Memo

To: The Atherton Planning Commission
From: Sally D Bentz-Dalton, Town Arborist
CC: Sung Kwon, Town Planner
Date: 4/20/23
Re: Tree Protection Zone (TPZ) Exception 345 Stockbridge

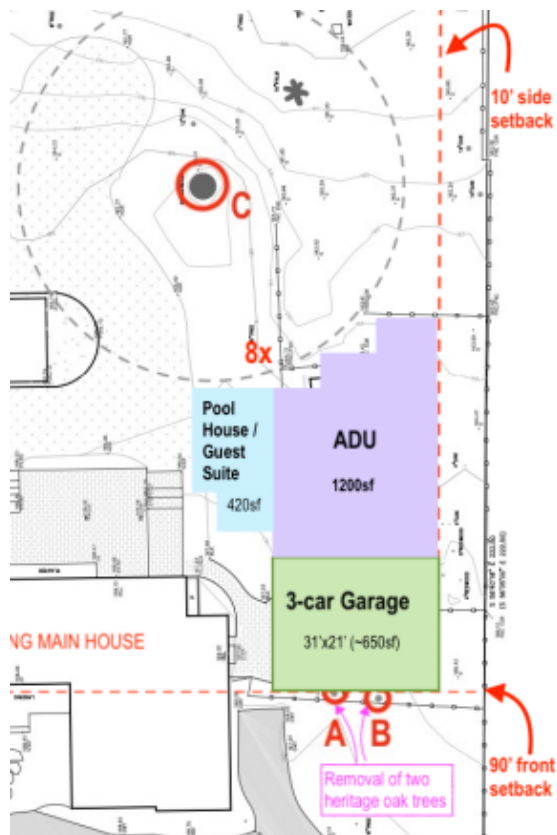
In July of 2022 I sent the homeowner a letter requiring the removal of Redwood, Tree C. The owner watered the tree on a regular basis which took much time and money and brought the tree back to life.

The applicant is asking for 6x TPZ for one structure that will be a garage, pool house and ADU. The existing conditions have a grade change, a shed and an area where a dead Redwood was.

The applicant is saying that for the part of the structure within 8x of Tree C, they will build it with slab on grade to minimize root cutting and potential root damage.

Tree C will need to continue to be watered during the extent of this project. I can recommend the 6x TPZ for the proposed structure because of the existing conditions and slab on grade within 8x TPZ.

- Hand excavation only within 8x TPZ
- The area under the drip line of trees should be thoroughly irrigated to a soil depth of 18” every 3-4 weeks during the dry months.
- Mulch should cover all bare soils within the tree protection fencing. This material must be 6-8 inches in depth after spreading, which must be done by hand. Coarse wood chips are preferred because they are organic and degrade naturally over time.
